ADDENDUM 03

Community Crisis Center
Helix Project No.24001.00

Issue Date: 7.28.25

A101

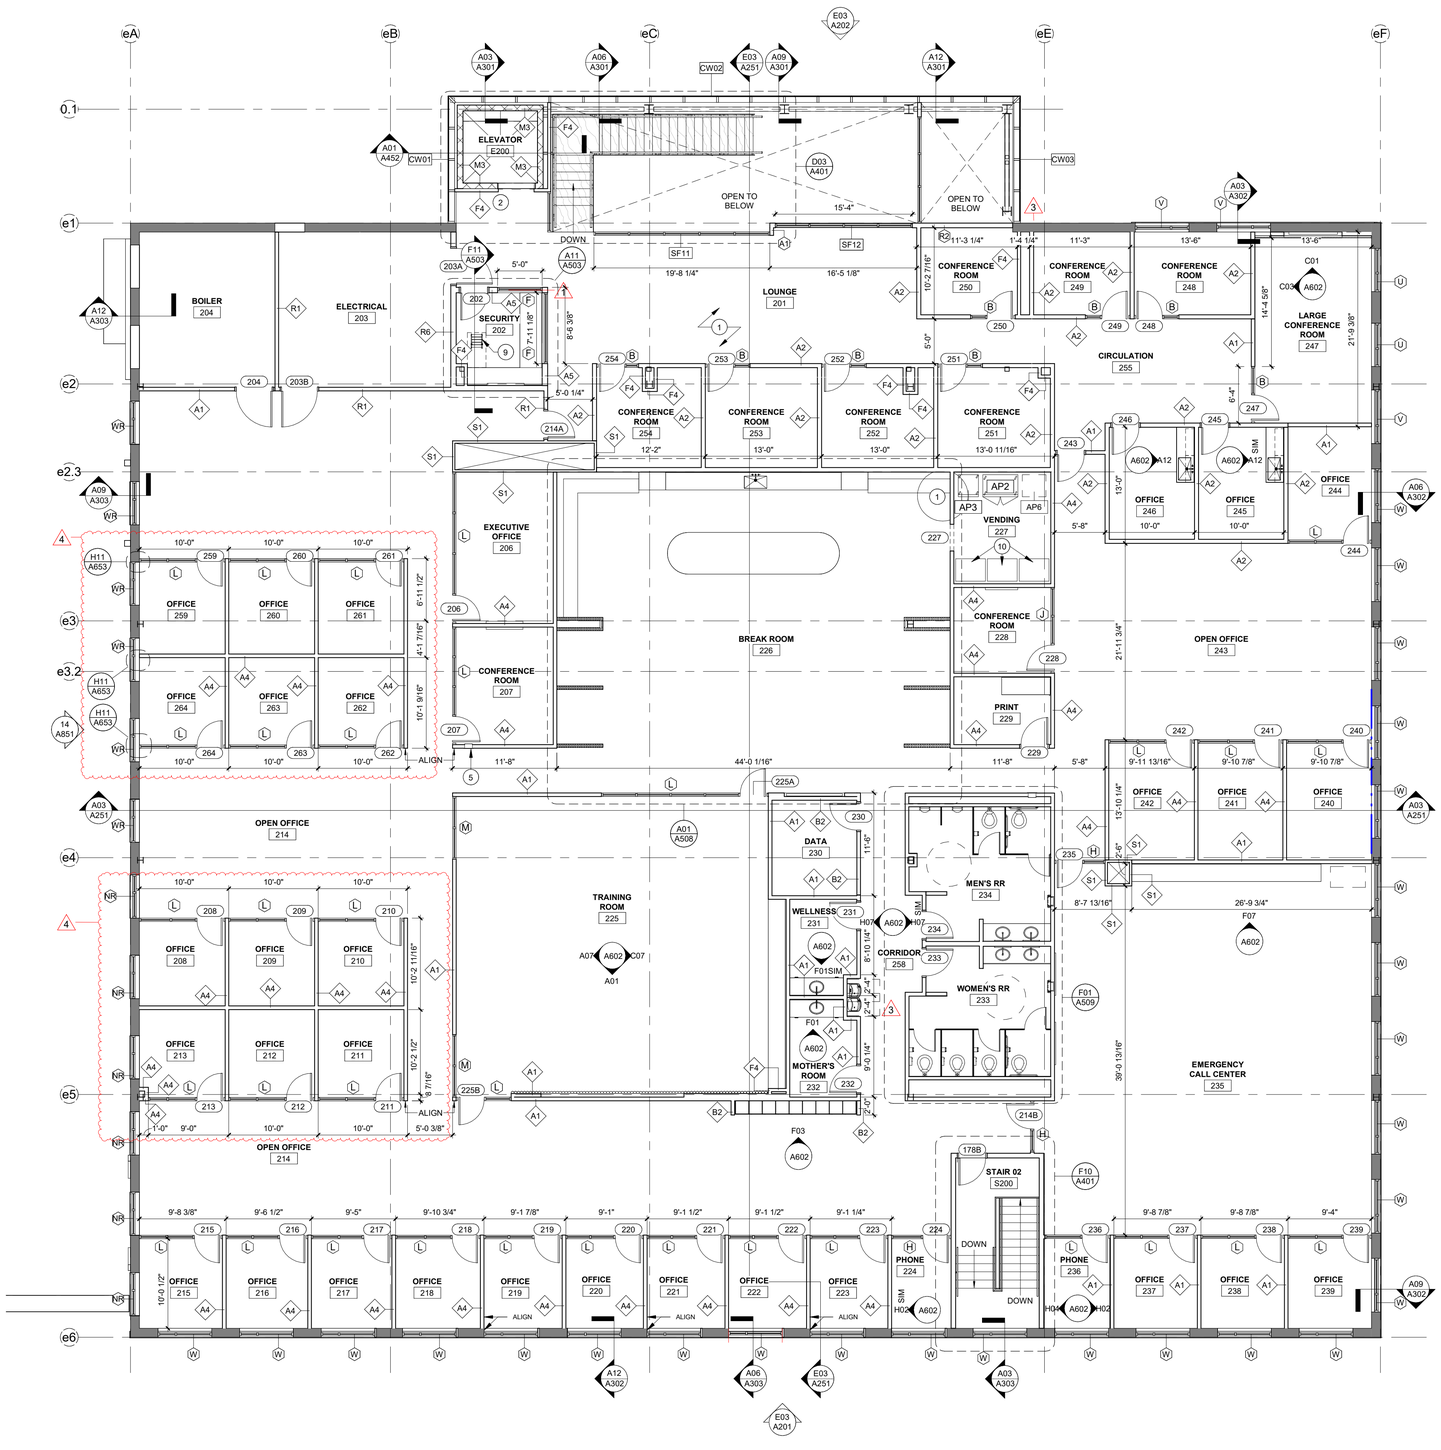
A101 – LEVEL 01 FLOOR PLAN
1. **REVISE** Office 159 to be Medication Storage Room 159.
2. **REVISE** Door 159 to be a solid wood door with no sidelite, Type C.
3. **REVISE** Patient Room 121 to be Office 121.
4. **REVISE** Door 121 to match all other private office doors and storefronts on Level 01.

A102

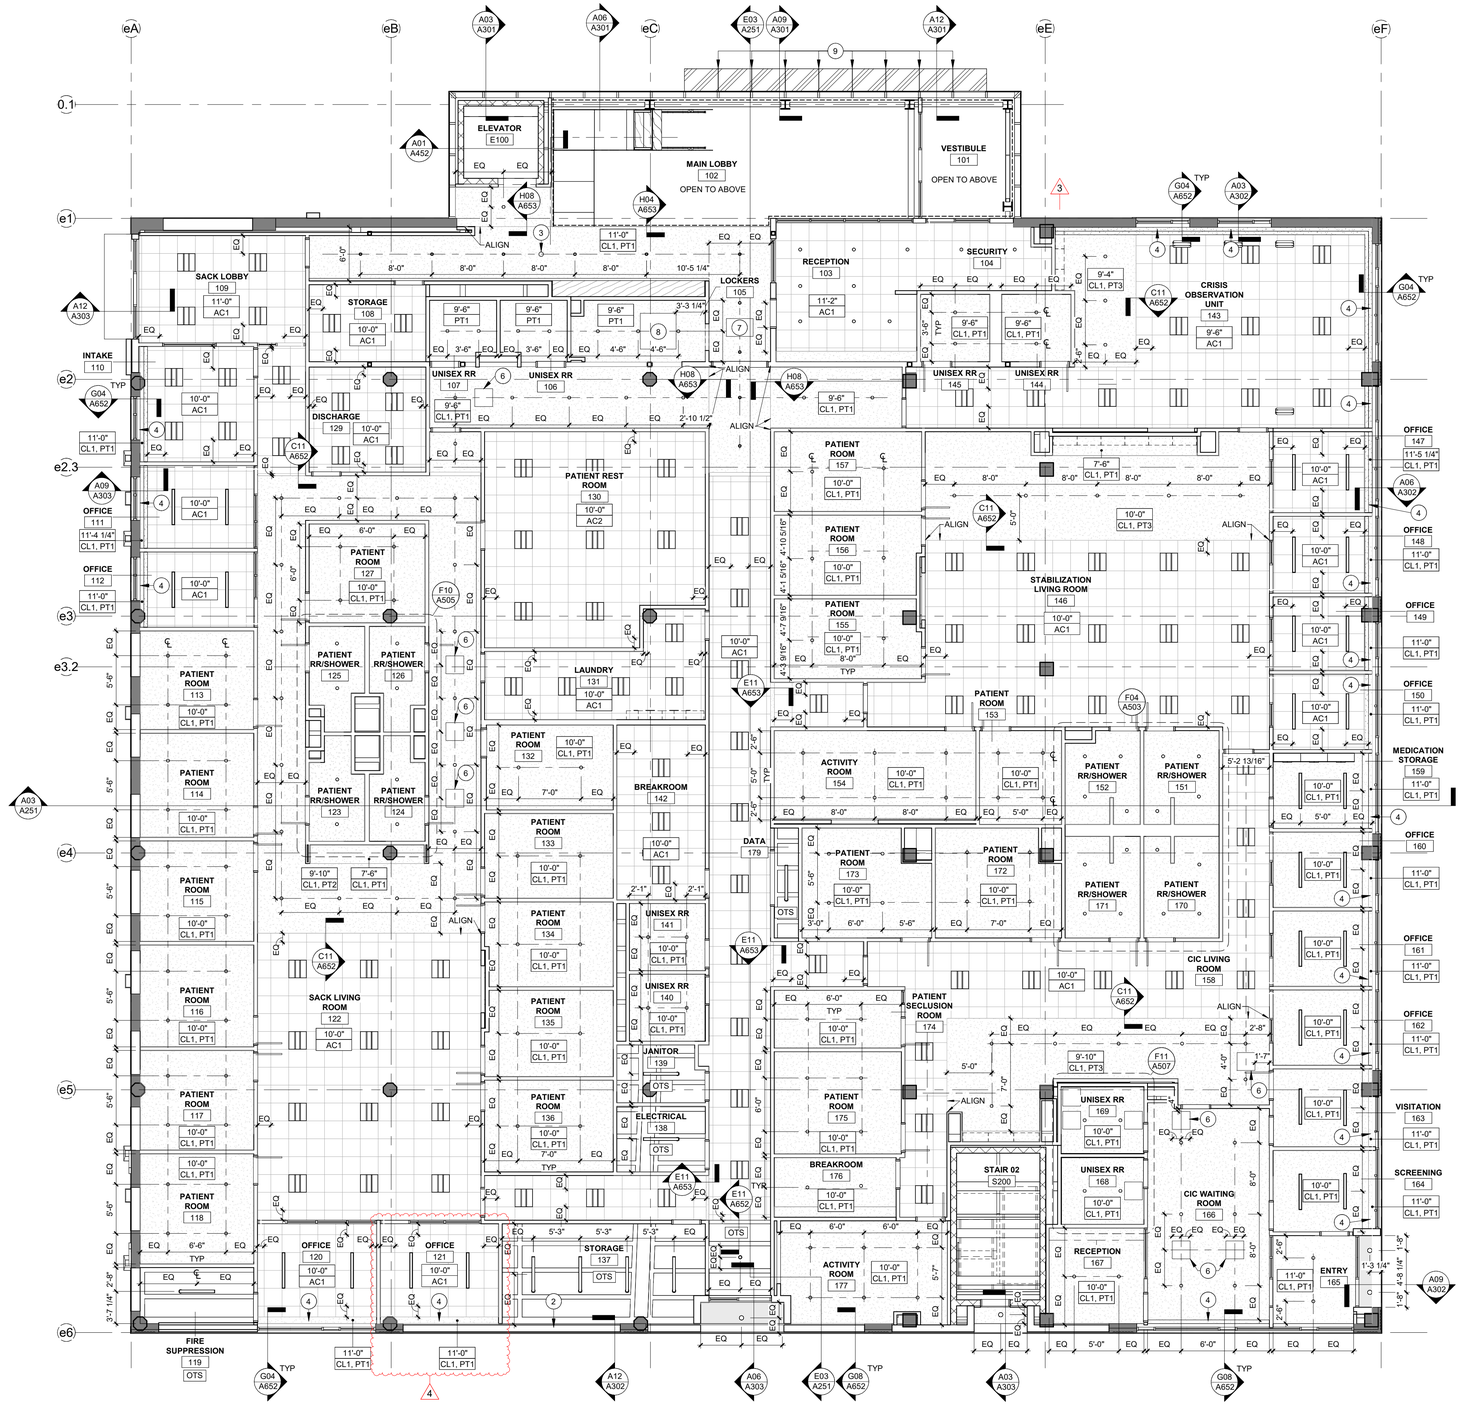
A102 - LEVEL 02 FLOOR PLAN
1. **ADD** six private offices to west side of plan, Offices 259 – 264.

LEVEL 01 REFLECTED CEILING PLAN
A151

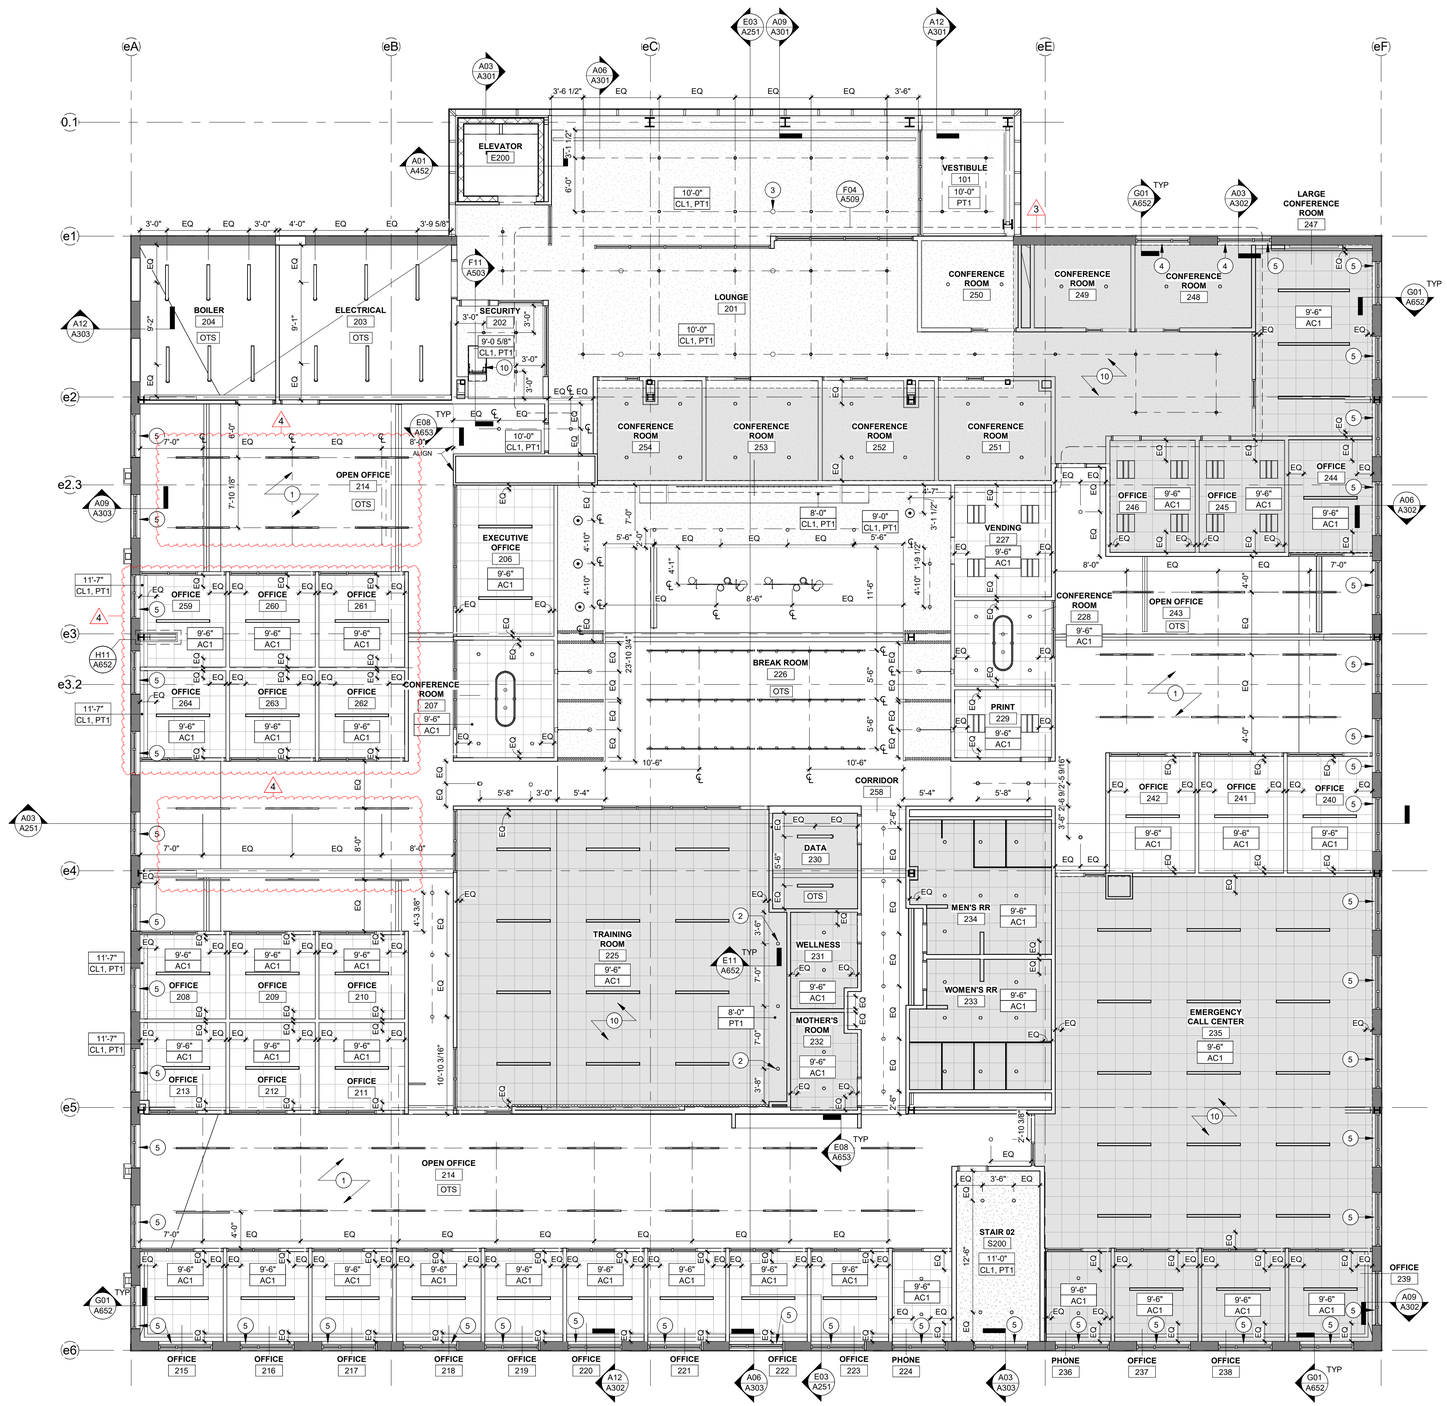
A151 - LEVEL 01 REFLECTED CEILING PLAN
1. **REVISE** ceiling at Office 121. Replace with 2’ x 2’ ACT and 4’ linear light fixtures.

LEVEL 02 REFLECTED CEILING PLAN
A152

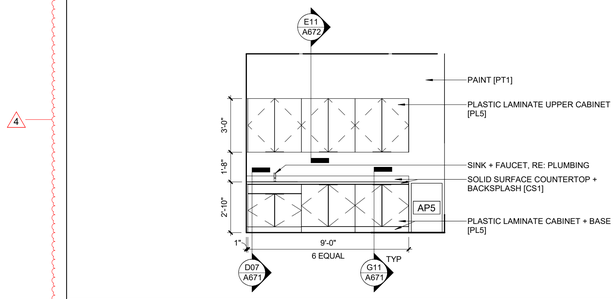
A152 - LEVEL 02 REFLECTED CEILING PLAN
1. **ADD** 2’ x 2’ ACT and linear light fixtures to Offices 259 – 264. Refer to mechanical and electrical drawings for more information.
2. **ADD** ceiling detail H11, metal trim surrounding structural penetration of ACT.

A701

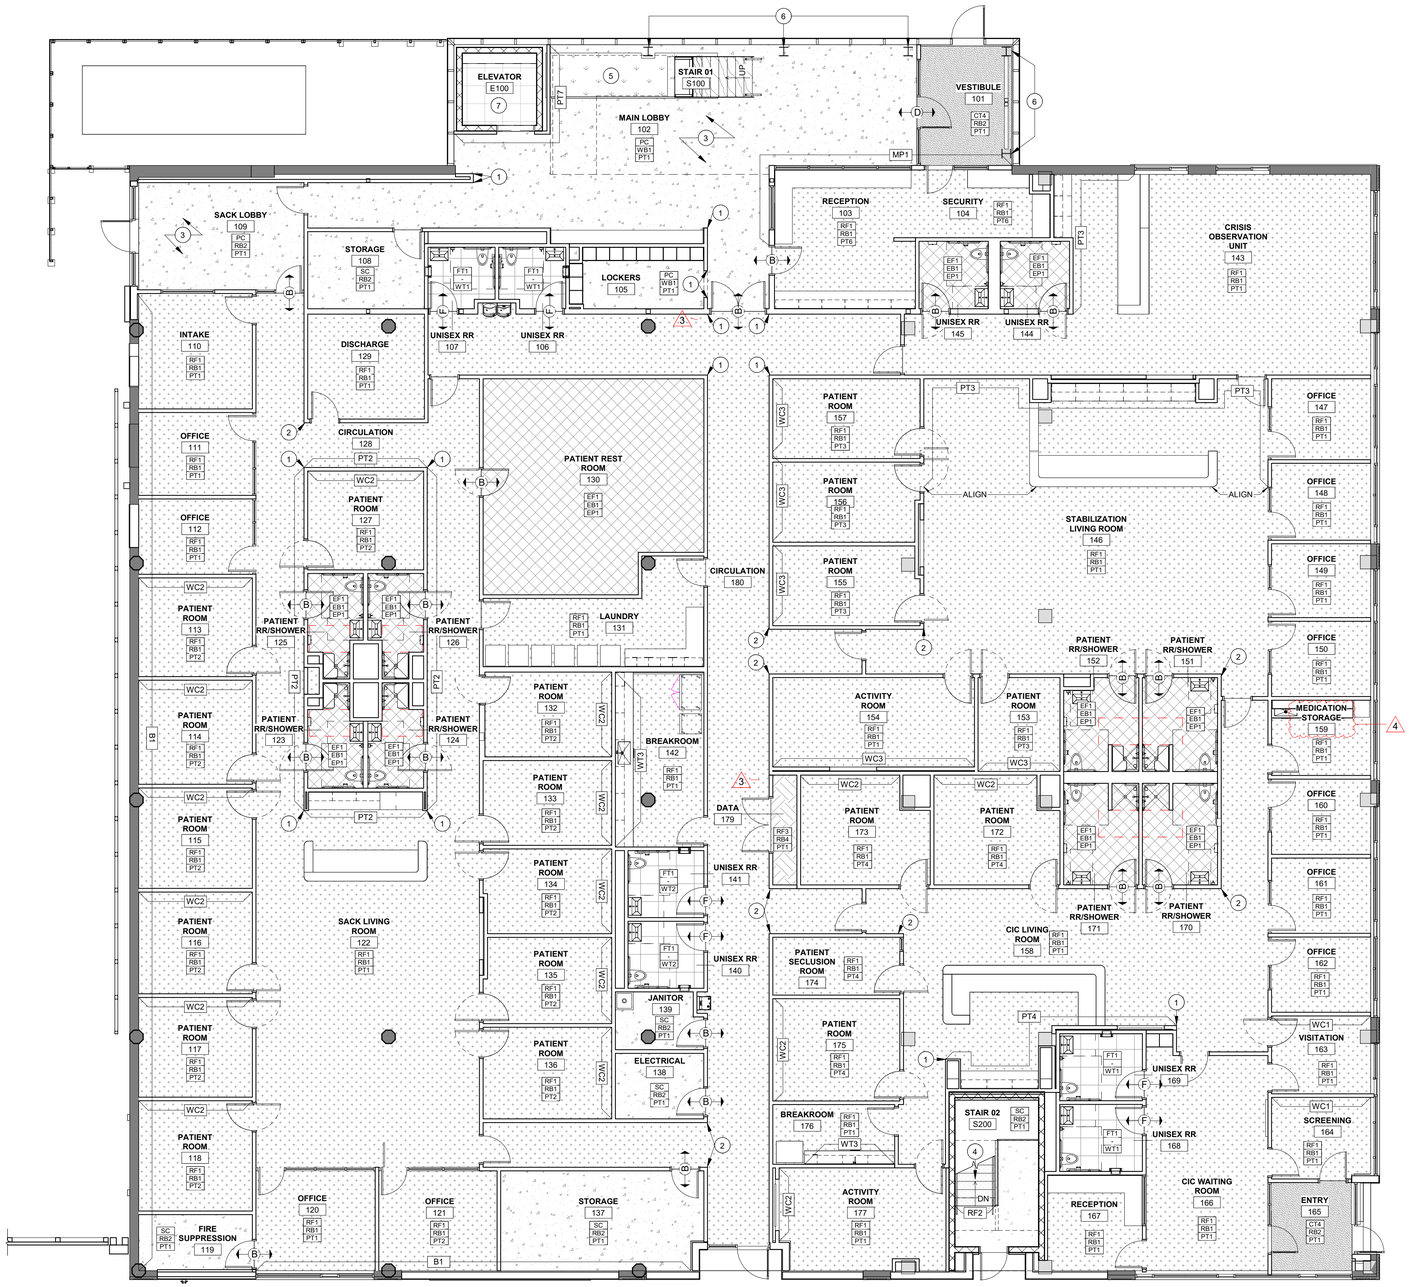
A701 - LEVEL 01 FINISH PLAN
1. **REVISE** Room 159 to be Medication Storage.

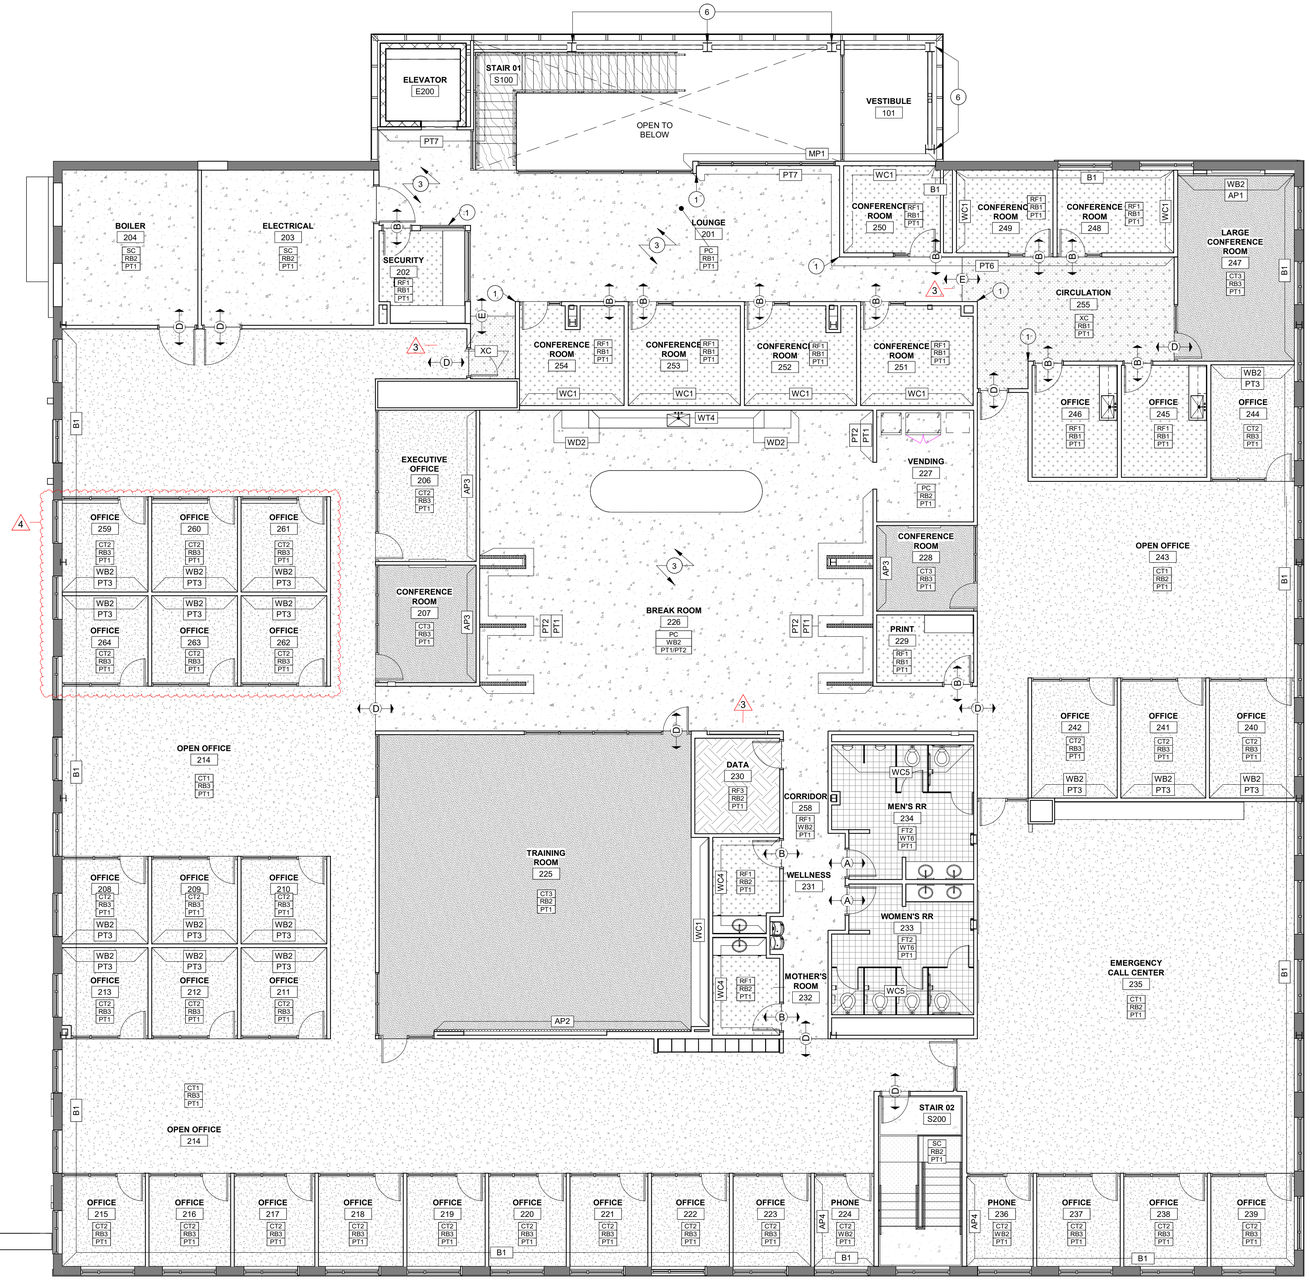
A702 - LEVEL 02 FINISH PLAN
1. **ADD** finishes to new private offices on west side of plan.
